March 8, 1994
G-1151-RSO-94-69

GTISL Program Report Form

GPRF No.: 94.05

GTISL PRODUCT NAME GTSTRUDL

Typical stiffening force-displacement behavior
for a nonlinear spring

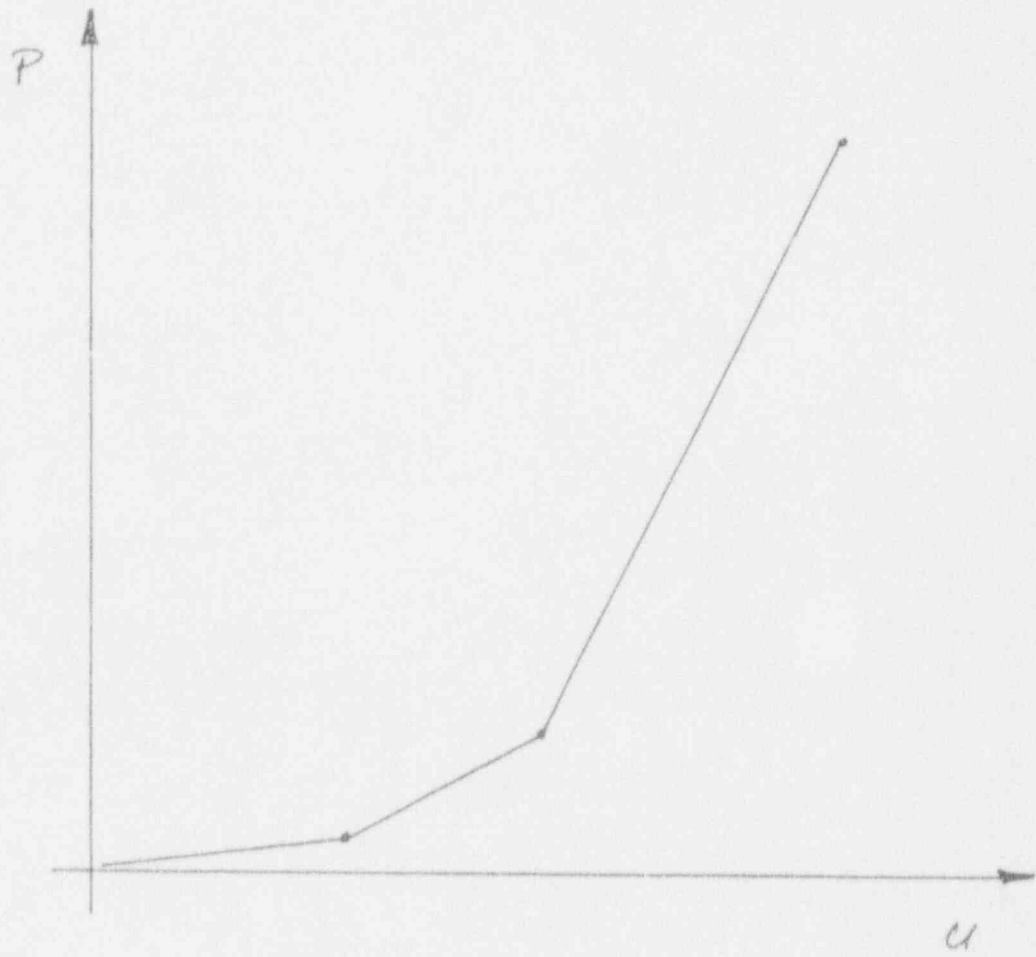
Nonlinear analyses of structures which have nonlinear spring supports will not converge for the case where force-displacement/moment-rotation behavior of the stiffening type is defined for one or more of the nonlinear springs (see figure on the attached page). There is no work-around for this problem.
